To: Members of Dublin City Council
From: Marsha I. Grigsby, City Manager *MLG*
Date: January 10, 2013
Initiated By: Steve Langworthy, Director of Land Use and Long Range Planning
Claudia D. Husak, AICP, Planner II
Re: Final Plat - Tartan Ridge, Section 5-1

**4. Tartan Ridge, Section 5-1 9327 Burnett Lane
12-080FDP/FP Final Development Plan
Final Plat**

Tartan Ridge – Section 5-1

Proposed Final Development Plan

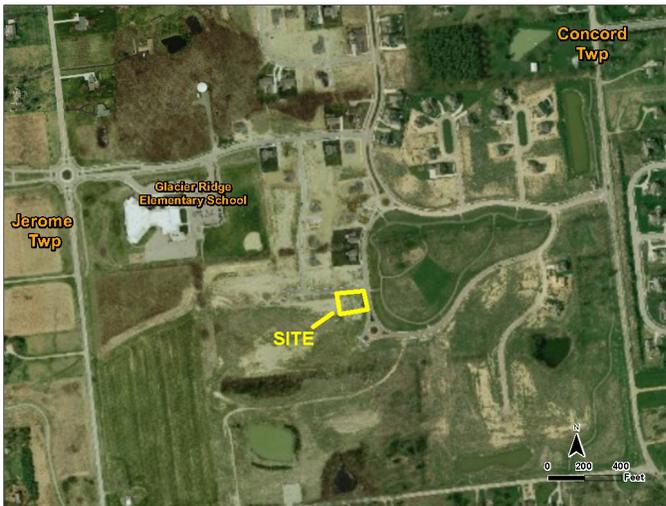
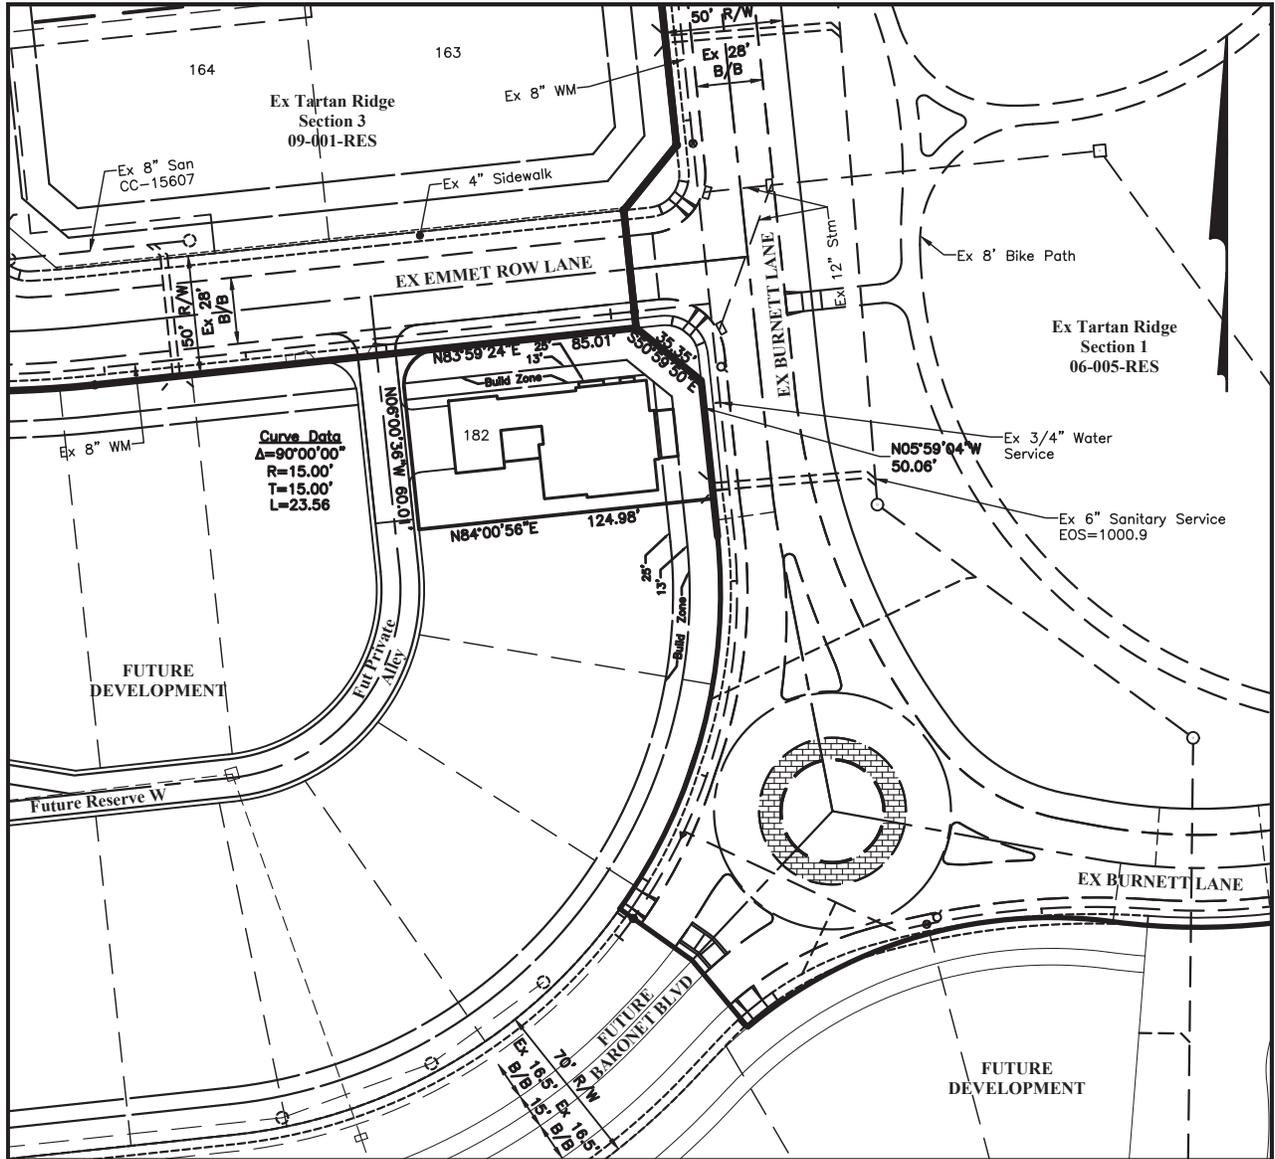
<p>Hedges</p>	<p>The approved development text requires that a hedgerow be located along the front of all residential lots. The proposed hedge plant material is to be installed at a minimum height of 18 to 24 inches and to be maintained at not more than 30 inches. The applicant has indicated that the Homeowners Association will be responsible for the maintenance of the hedges.</p> <p>The hedge material for Emmet Row Lane is green velvet boxwood and dwarf burning bush for Burnett Lane. Planning requests the graphic illustrating the hedge</p>

Details	Final Development Plan
	requirement be updated for alley accessed homes.
Gates and Gateposts	The text requires either a gate or gateposts at the front of each lot at the terminus of the brick sidewalk, which will be required to be integrated with the landscape hedge. The plan includes a sampling of gates, posts, as well as arbors and trellises as an illustration of the intended design character. Allowed materials include wood, stone, brick, and wrought iron. Other types of gates, posts, and trellises may be utilized as long as the style and intent of this feature is maintained.
Fences	The development text allows fences at a height of six feet within the buildable area of the lot to enclose the rear courtyard of homes. The fences must be complementary to the architectural style of the home and require approval from the Planning and Zoning Commission. Planning will require the applicant to provide a palette of architectural appropriate fences to the Commission for review and approval at the final development plan stage for the remainder of the alley loaded homes.

7) <i>Appropriate landscaping to enhance, buffer, & soften the building and site</i> Conditions 1 and 2	Criterion met with Conditions: The plan incorporates the hedge requirement as outlined in the development text. The graphic in the final development plan should be revised to illustrate alley accessed homes. The applicant will also be required to provide a palette of architecturally appropriate fences for approval by the Commission with the final development plan for the remainder of the alley accessed lots. Lot 182 will be required to adhere to one of these approved fences.

The applicant had met the first condition and revised the graphic regarding the hedge exhibit. The second condition will be met with the final development plan for the remaining lots.

- 1) That the applicant revise the hedge installation graphic to reflect alley accessed lots prior to scheduling the plat for City Council review; and
- 2) That any fence for Lot 182 be selected from an architecturally appropriate palette to be approved by the Planning and Zoning Commission as part of the final development plan approval for the remaining alley lots.
